ADDENDUM #2

PROJECT: Hill City WWTF Improvements

ADDENDUM NO. 2
TO
PROJECT DOCUMENTS
FOR
HILL CITY WWTF IMPROVEMENTS PROJECT
FOR
HILL CITY
HILL CITY, SOUTH DAKOTA

- Drawing Sheets
 - GEN E002 (Addendum 2)
 - PTB E102 (Addendum 2)
 - PTB E604 (Addendum 2)
 - SBR E801 (Addendum 2)
 - PB P101 (Addendum 2)
 - PB P601 (Addendum 2)
 - PB E104 (Addendum 2)
 - PB E603 (Addendum 2)
 - PB E801 (Addendum 2)
- Specifications
 - 46 41 00 Mixing Equipment – Addendum No. 2

1 SUBGRADE LEVEL ENLARGED ELECTRICAL PLAN VIEW
E104

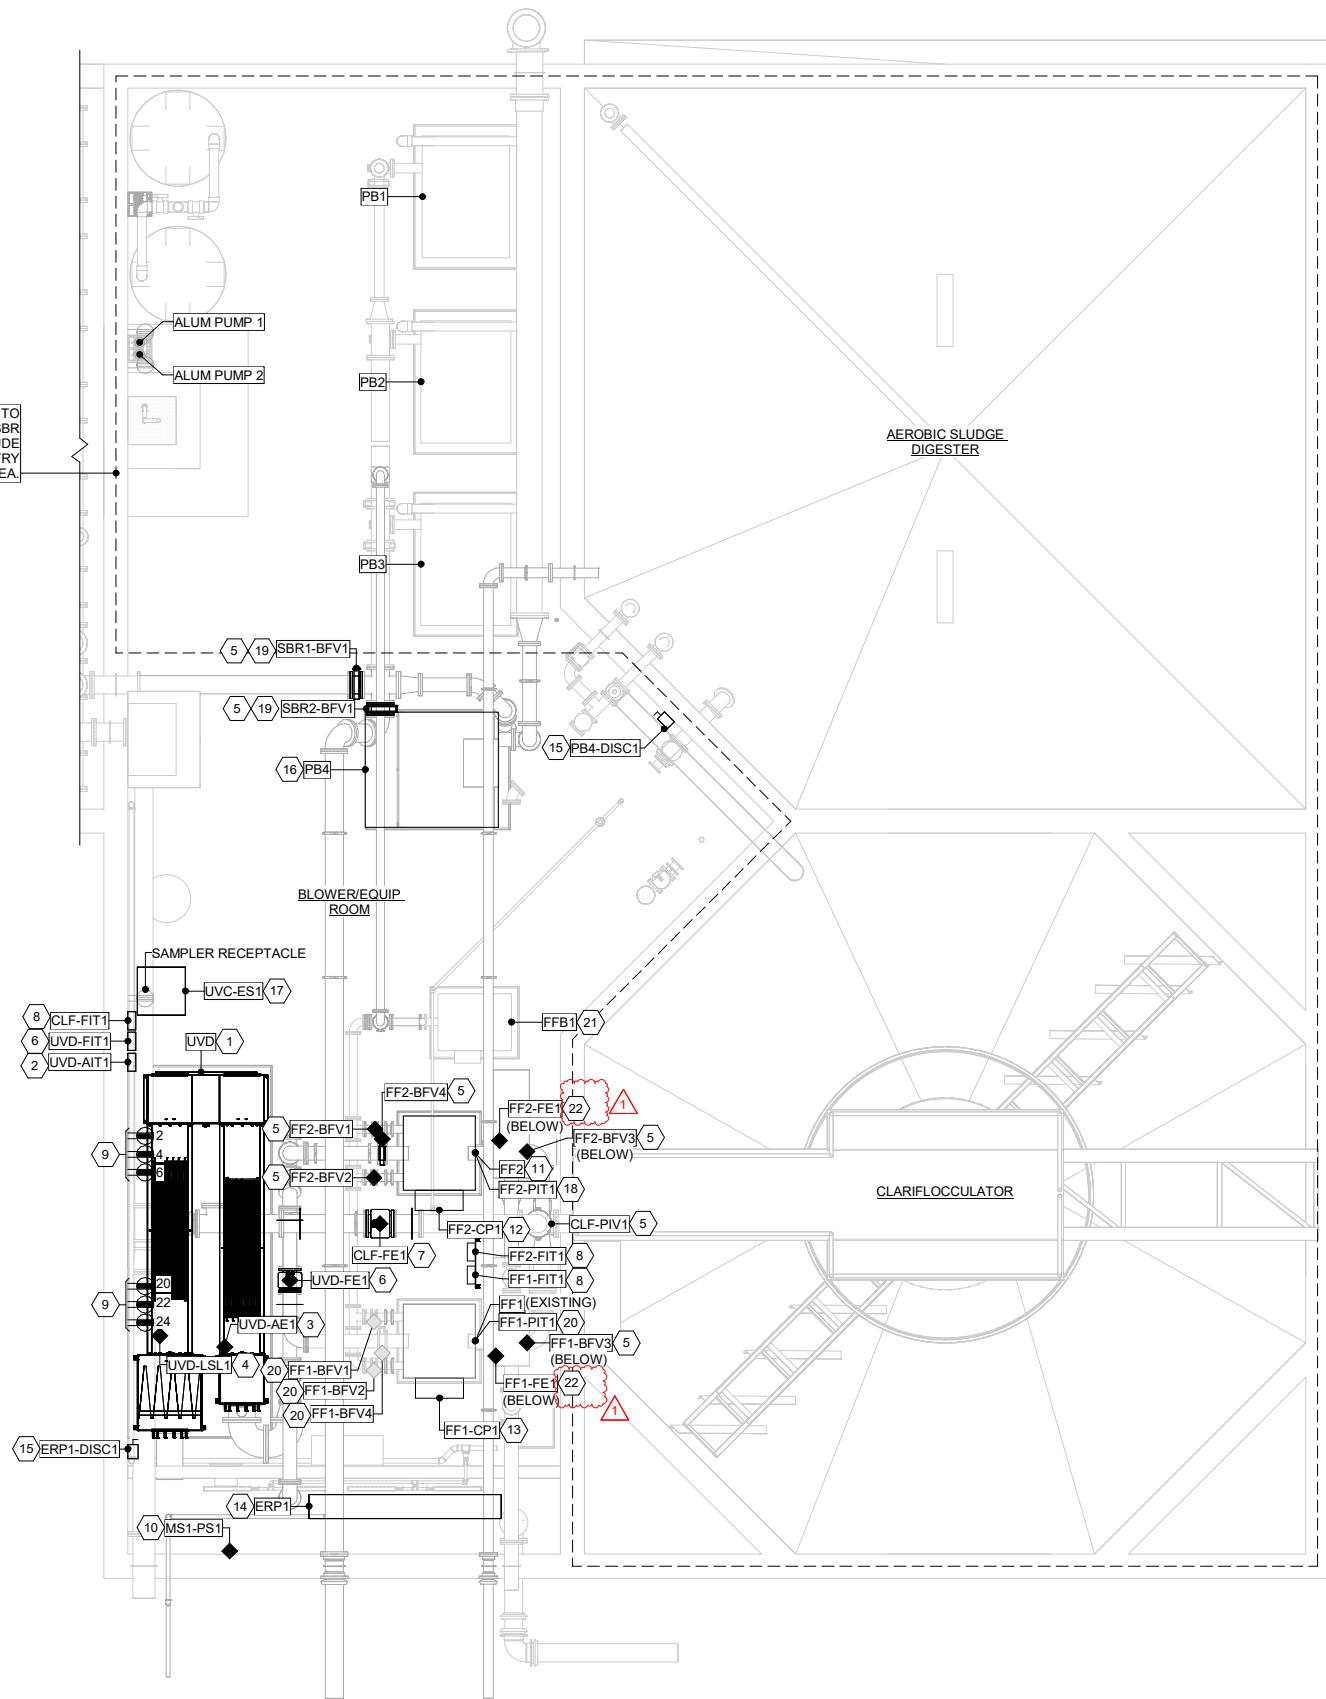
1. **Add** Construction Note 22 as follows: "MAGNETIC FLOWMETER FURNISHED AS PART OF FUZZY FILTER PACKAGE (46 61 21) AND INSTALLED BY CONTRACTOR."
2. **Modify** Construction Note callouts for 'FF1-FE1' and 'FF2-FE1' from Note 7 to Note 22.
